Wrentham Planning Board
Wrentham Town Hall
79 South Street
Wrentham, MA 02093

Re: Application for Special Permit/Site Plan Approval – 10 Commerce Boulevard (“Lot 1”)

Figure 1

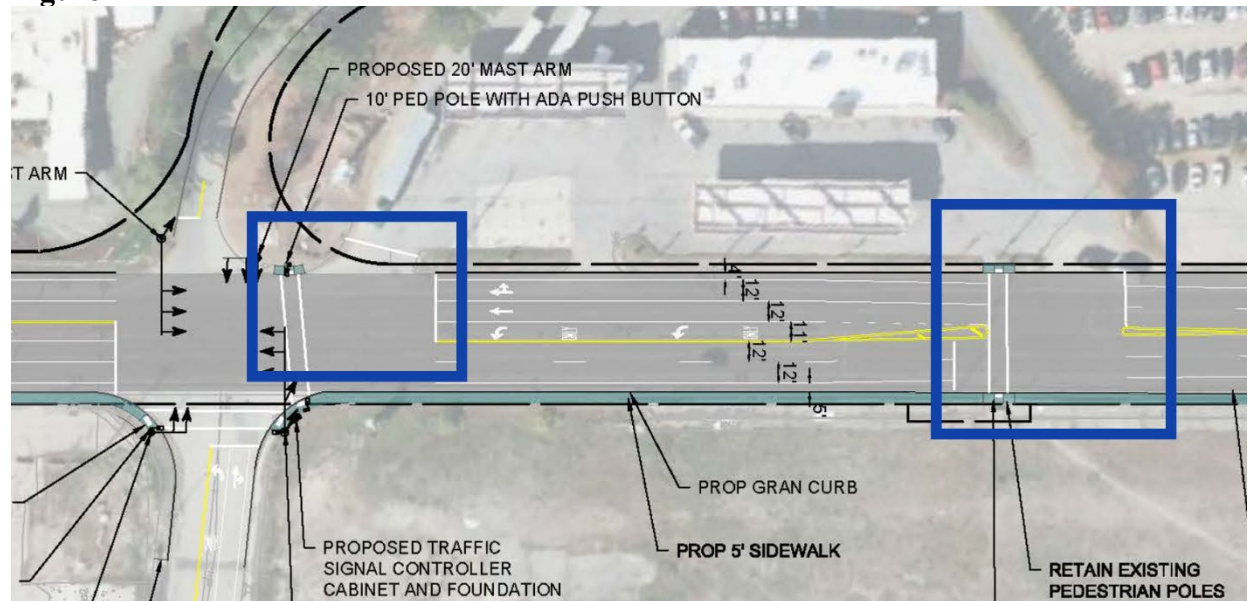
In last year’s filings, ND committed to accommodations, which included providing access into the intersection for Turnpike and the Interstate Plaza, located on the west side Route 1. Specifically, in its FEIR, ND stated that “[i]n the future, through the development of Lot 1, a connection could be implemented to the Turnpike Truck Parts property located south of Commerce Boulevard. This future connection would allow traffic to and from Turnpike Truck Parts to utilize the proposed signal. While not currently finalized, the site layout of Lot 1 has been configured in order to accommodate the potential connection to the south.”³ For Interstate Plaza, ND proposed to locate the stop bar for Route 1 (southbound) several feet back from where it would typically be, to allow Interstate Plaza’s patrons to enter and exit through the signalized intersection. The signal was proposed to contain a specific phase (light) serving the Interstate Plaza driveway.⁴ See, Figure 1 below (annotated excerpt from “signalization concept plan” attached to FIER, p. 41).

Figure 2

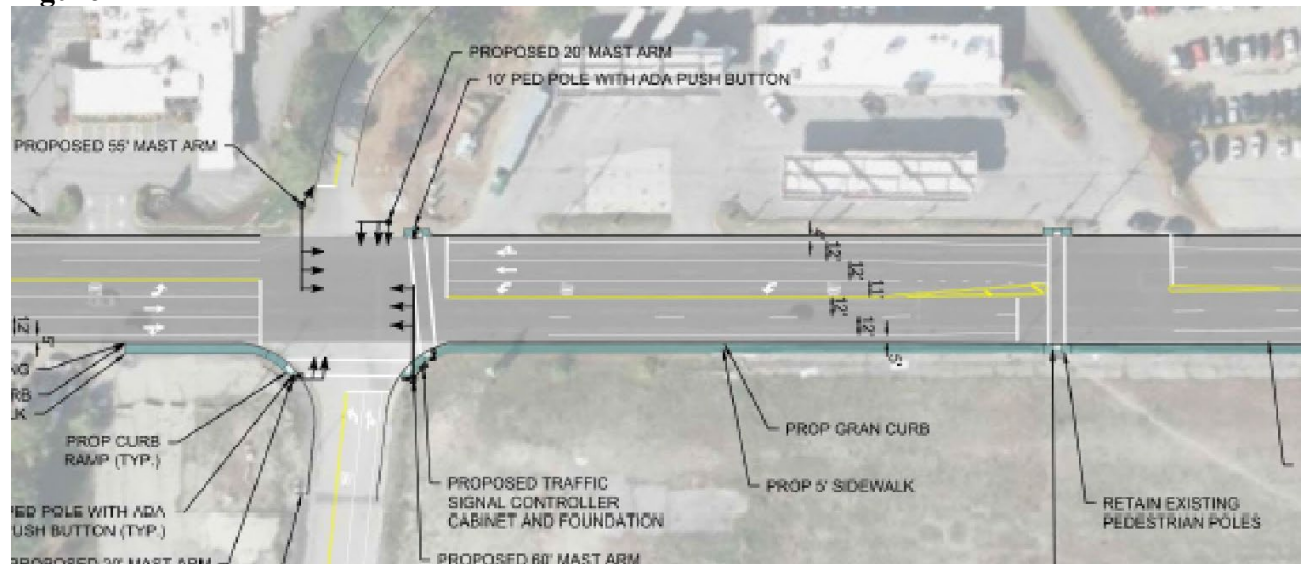
In its most recent MEPA filing, a “Supplemental Final Environmental Impact Report” (“SFEIR”) that was filed in August, 2023 (after the special permit for the warehouse on Lot 3 was granted), ND changed course. ND is still proposing to signalize this intersection, but it has declared that it is no longer incorporating any access accommodations to Interstate Plaza and Turnpike Truck Parts properties. Notably, the revised “signalization concept plan” moves the southbound stop bar forward, blocking Interstate Plaza’s driveway exit, and leaving no safe way for vehicles exiting Northbound to cross traffic. See, Figure 2 below (plan attached to SFEIR, p. 33). Interstate Plaza’s customers will no longer have a dedicated exit into this intersection, making traffic operations less efficient and less safe.

ND states on page 35 of its SFEIR, “[w]ith the new proposed build program for Lot 1, access that was previously proposed to the property south of the project site is no longer included in the proposal and the approaches to the new signal are expected to only include Washington Street (Route 1), Commerce Boulevard, and Hawes Street.”⁵ ND further states that “[a]n easement area over Lot 1 has been reserved in order to accommodate potential future shared access,”⁶ but no immediate safe access is proposed. We do not see any such easement area marked on the current Lot 1 plans. Notably, however, the predicted queuing that will be experienced in front of abutting properties is significantly longer than the queuing depicted in ND’s prior MEPA filing.⁷

This is a major step backwards, and contravenes the clear admonishment from the state Secretary of Energy and Environmental Affairs in her November 14, 2022 MEPA Certificate (FEIR Cert., p. 9) that the Proponent continue consultations with MassDOT on developing a sound “access management plan” for this intersection, which should include consideration of the directly affected abutters.⁸ ND’s retreat from its prior commitment is disturbing and contrary to the sentiments expressed by several of the Board members during the prior public hearings.
